Harper Canyon (Encina Hills) Subdivision Project
Final Supplemental
Environmental Impact Report
SCH# 2003071157
PLN 000696

December 2024

County of Monterey
2441 Schilling Place
Salinas, California 93901

Denise Duffy & Associates, Inc.
947 Cass Street, Suite 5
Monterey, California 93940

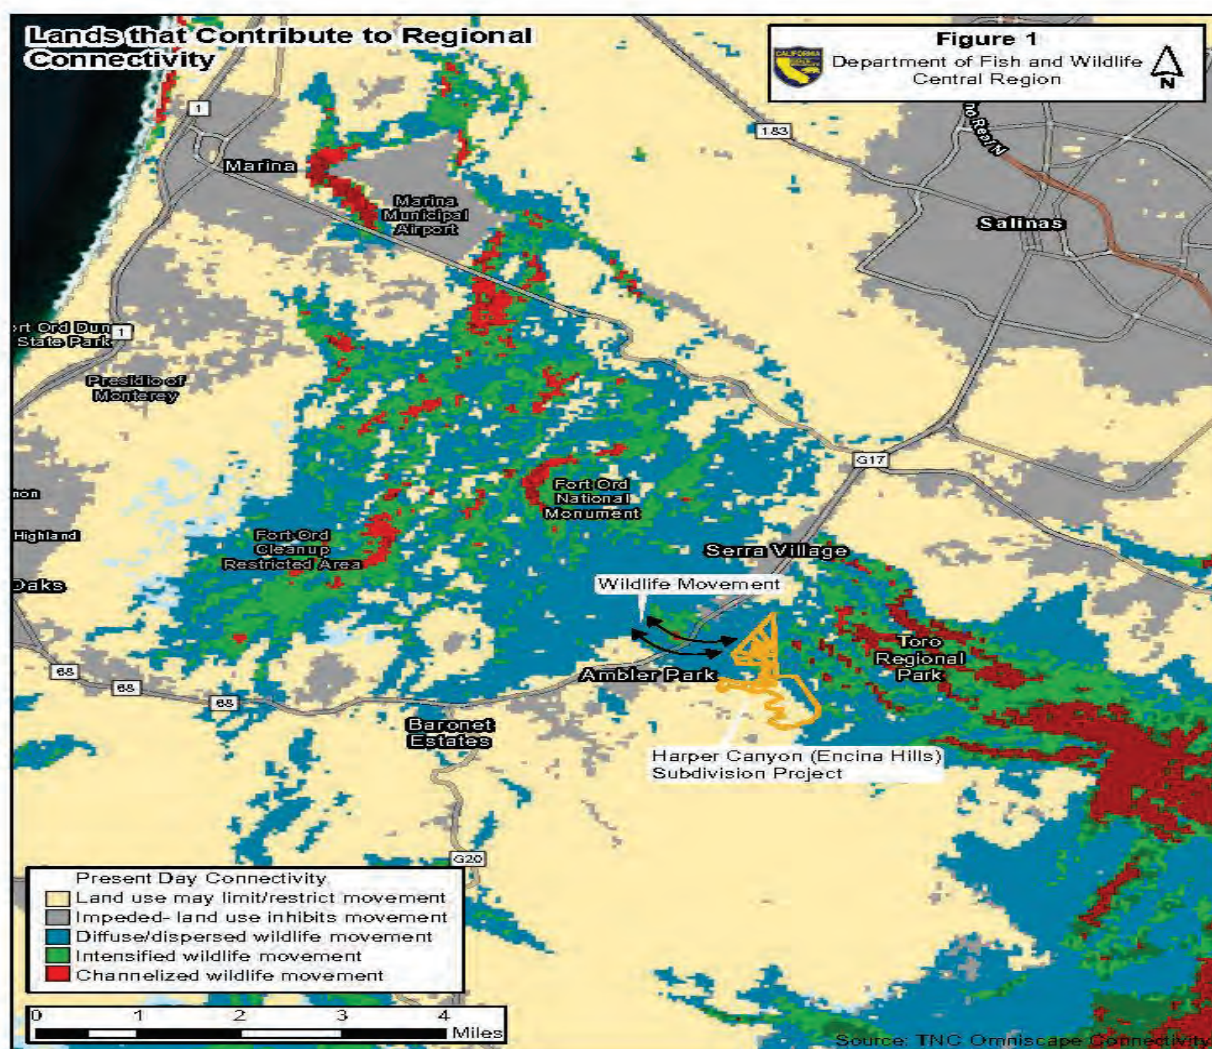
The Project's 17-lot residential subdivision would almost entirely block a primary wildlife corridor between Fort Ord and Toro Park and further isolate Fort Ord and the wildlife species that inhabit the monument (Attachment 1, Figure 1). Attachment 1, Figures 1 and 2, utilize The Nature Conservancy (TNC) Omniscape Connectivity Web Map (TNC 2024) dataset to model wildlife movement within and surrounding the Project site. As Attachment 1, Figures 1 and 2, depict, the majority of the residential subdivision is directly within the sole migratory pathway between Fort Ord and Toro Park. While the SDEIR recognizes the potential impacts to wildlife connectivity associated with the siting of the Project site, and specifically provides mitigation measures to protect a portion of the El Toro Creek corridor, CDFW is concerned that without the protection of the surrounding movement pathways identified in Attachment 1, Figures 1 and 2, the Project would not adequately mitigate for the impacts to wildlife movement.

The comment acknowledges that the mitigation measures identified in the SDEIR protect a portion of the El Toro Creek corridor. However, the comment expresses concern that without protection of the surrounding movement pathways (identified in Figures 1 and 2 of the attachment to Letter E), that project would not adequately mitigate for the impacts to wildlife movement. As stated in this response, the proposed project would provide additional

protection of the surrounding movement pathways by maintaining a 180-acre open space parcel, donating 154 acres of that parcel to expand Toro County Park. Portions of this parcel fall within the diffused/dispersed movement areas, which are those categorized by The Nature Conservancy as areas with high flow (e.g., areas of open space with limited human modification). It should be noted that the other surrounding movement pathways identified as diffused/dispersed movement areas in Figures 1 and 2 include the Fort Ord National Monument, Toro County Park, and Marks Ranch, which are currently protected as open space. Lastly, as a mitigation requirement, corridors through the project site will be identified in the final map where no development shall occur.

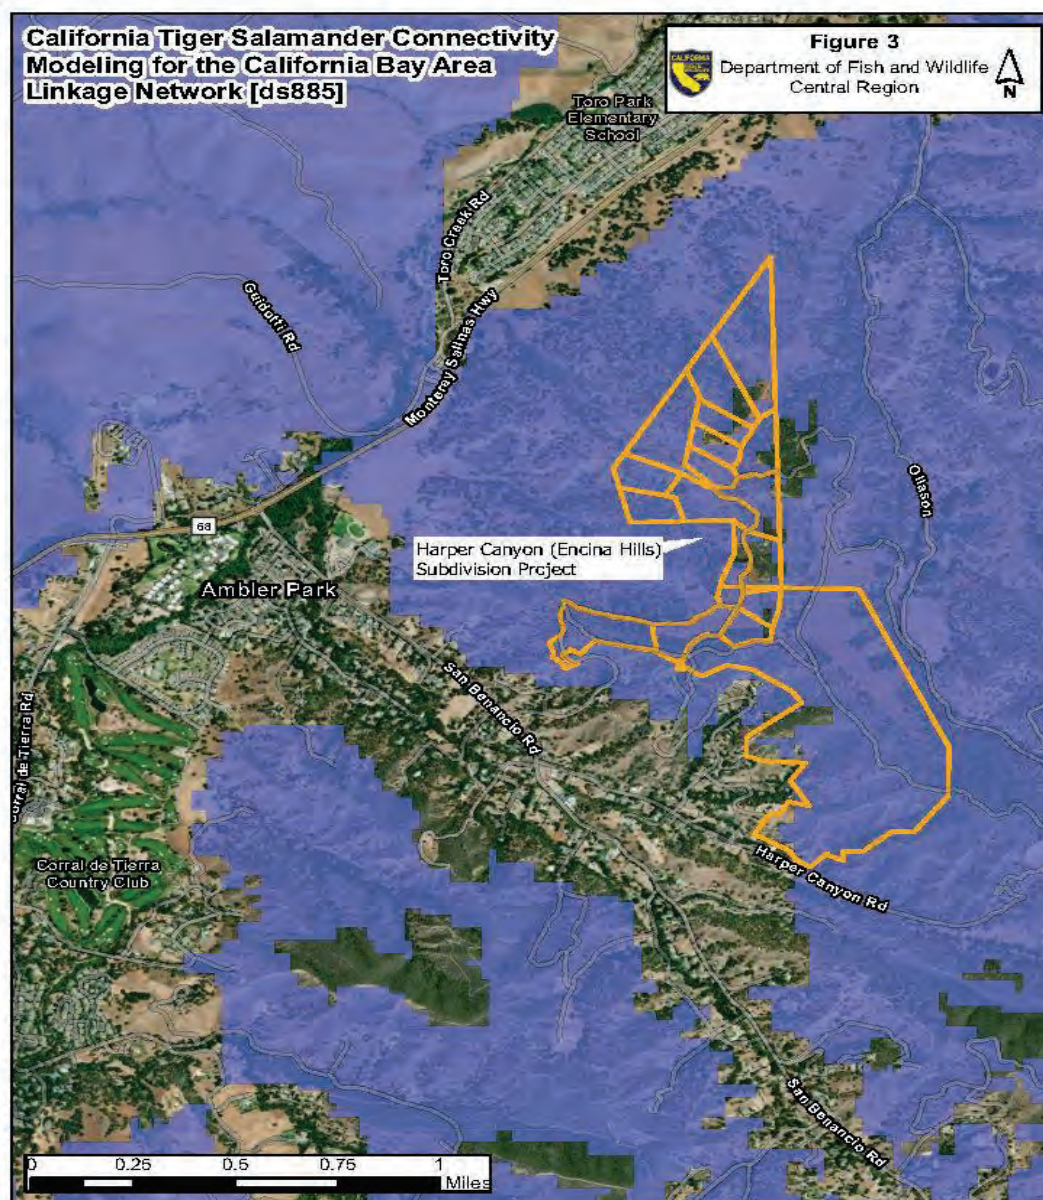
The Project site is within the known range of CTS and contains suitable habitat for the species, and CTS have been documented within both Fort Ord and Toro Park (CDFW 2024). Additionally, it does not appear that CTS surveys have been conducted since 2012, and the original surveys were potentially not adequate to detect CTS. CDFW would like to highlight the importance of the Project site for CTS connectivity, movement, and breeding. Attachment 1, Figure 3 illustrates potential areas of breeding habitat for CTS within the Project site. The highlighted areas (i.e., blue areas) within Attachment 1, Figure 3, depict (similarly to Attachment 1, Figures 1 and 2) that the Project is within an essential linkage area between Fort Ord and Toro Park for CTS breeding and movement. Any development within the Project site would likely limit genetic diversity and gene flow, impact the resiliency of CTS populations, and potentially impact entire CTS populations over time.
